ORDINANCE NO. OR10-24

FINAL PUD STAFF REPORT (May 28, 2024 Meeting)

PL-2024-12 (Final PUD Phase II Gated Properties)

C-1.0

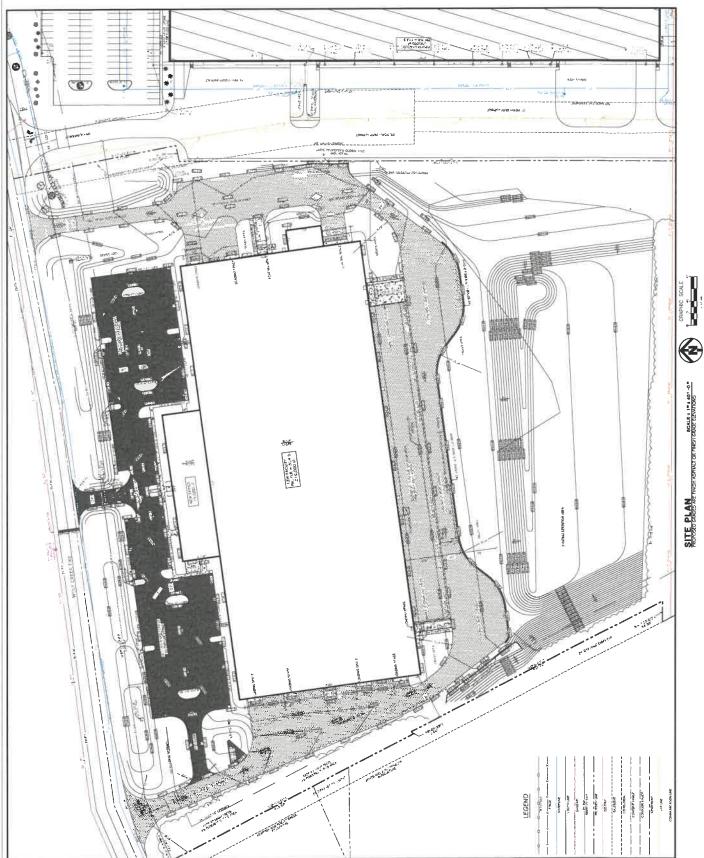
- 1. The road improvements are currently not shown on the site plan. These will need to be shown on the plans before final approval from staff and must be completed prior to the building being used. TCO 1115.06, 1115.07, 1115.08, 1115.09

- 2. The amount of parking spaces provided does not meet the Zoning Ordinance requirement. TCO 1181.05
- 3. The applicant is proposing outdoor storage that is not screened with a 6-foot 100% opaque fence as the code would require. They are instead proposing a 6-foot chain link fence that is screened by landscaping. TCO 1189.06

- 4. The applicant is proposing 3 curb cuts, where the Zoning Ordinance limits properties to 2 curb cuts. TCO 1113.10(b)
- 5. The proposed plan is missing a total of 48 trees they are required to plant. The Commission should decide if the landscape plan is sufficient, if they need to plant the additional 48 trees on site, or provide a payment in lieu of in order for the city to plant 48 trees somewhere throughout the City at its discretion.

- 1. The applicant is proposing a Final PUD site plan for an industrial user with a focus on manufacturing. The plan includes a 216,000 square foot building for industrial use and a 15,000 square foot portion of the building to be used as an office. It also includes a parking area with 178 total parking spaces, one curb cut for commercial vehicles, and two curb cuts for industrial truck traffic (one entrance and one exit).

- 5. The Zoning Ordinances states that for every 1000 square feet of building area, 1 parking space is required. For this proposed use, the Zoning Ordinance requires 235 parking spaces. The applicants have indicated that they do not expect any issues with the 178 parking spaces they have provided due to the number of staff and timing of shifts.

- 6. The Zoning Ordinance states that for any non-residential lot over 199 feet in frontage, a maximum of 2 curb cuts are permitted. The subject property has 650 feet of frontage and the applicants are proposing a total of 3 curb cuts. There is one curb cut in the middle of the property that will be used for employee and guest parking and one curb cut on each end of the property that will be used for semi-truck traffic. The curb cuts on the far ends will be used almost entirely for semi-truck traffic and are one-way to create an orderly flow of traffic.

- 8. The Zoning Ordinance states that any outdoor storage is required to be screened by a 6-foot 100% opaque fence, such as a wood fence. The applicants have proposed outdoor storage that is instead screened with a 6-foot-tall chain-link fence and landscaping that they believe should hide it from view. The outdoor storage is also located on the rear of the building and as such, it is very unlikely anyone from the public would be able to see the outdoor storage.

- 1. A variance from TCO 1181.05 to allow 178 parking spaces instead of the 235 parking spaces required.
- 2. A variance from TCO 1189.06(a) to allow an outdoor area to be screened by a combination of a 6-foot chain-link fence and the proposed landscaping.
- 3. A variance from TCO 1113.10(b) to allow a total of 3 curb cuts, as proposed in the provided site plan.

Sidney, Chio
Bear, Citosser; Tele
Bayon, Chio
Bayon, C LANDSCAPE PLAN [-1.1

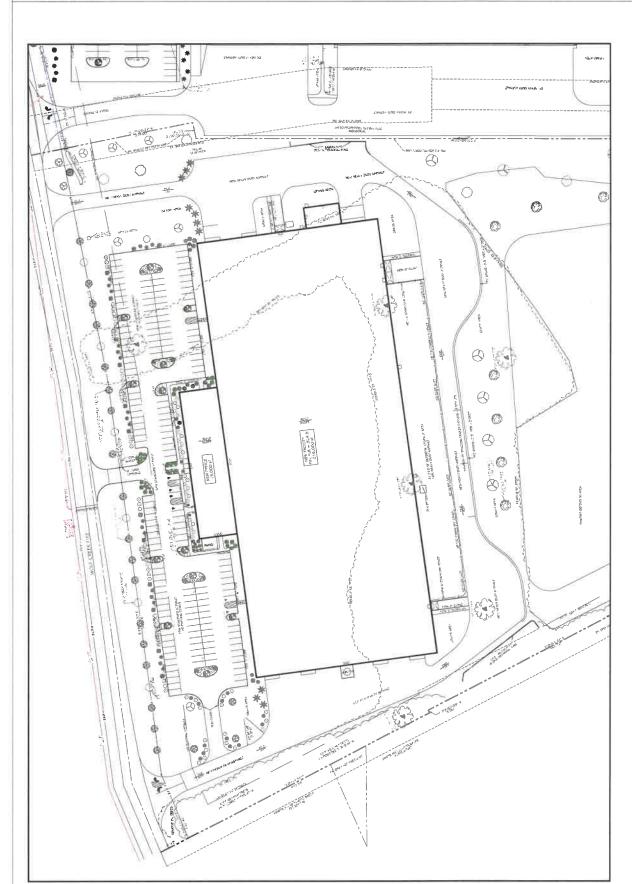
- 9. The applicant is proposing a landscape plan that does not meet the exact specifications of the Zoning Ordinance, but staff believes meets the intent of the Ordinance. The applicant is required to provide landscaping in the following areas:

- Wolf Creek Pike Frontage 19 Trees and 216 shrubs
 - o Parking Lot Interior 62 Trees
 - o Monarch Tree Replacement − 75 Trees
- 10. The applicant is providing the following in key locations throughout the development

- Wolf Creek Pike Frontage 24 Trees and 87 Shrubs
 - o Parking Lot Interior 34 Trees and 138 Shrubs
 - Stormwater Detention Area Behind Building 23 Trees

- Bike Path 27 Trees
- 11. Below are the totals of trees and shrubs provided versus what is required:
 - o Provided 108 Trees and 225 Shrubs
 - o Required 156 Trees and 216 Shrubs

- 12. Overall, the applicant is providing more landscaping than required in some areas and less than is required in others. However, staff believes this landscape plan to be a good alternative as to what is required, as it allows interior landscape islands to include shrubs instead of only trees. It also spreads out the landscaping more as opposed to concentrating it along the frontage. The applicant is proposing 48 less tress than what is required and staff believes that the best solution would be for the applicants to provide a payment in lieu of. This would cover the cost of the purchase and planting of those 48 trees. This payment would be made to

- the City of Trotwood so that the City could, at its discretion, locate those 48 trees somewhere else in the city that might be in greater need. The Zoning Ordinance indicates this is permitted.
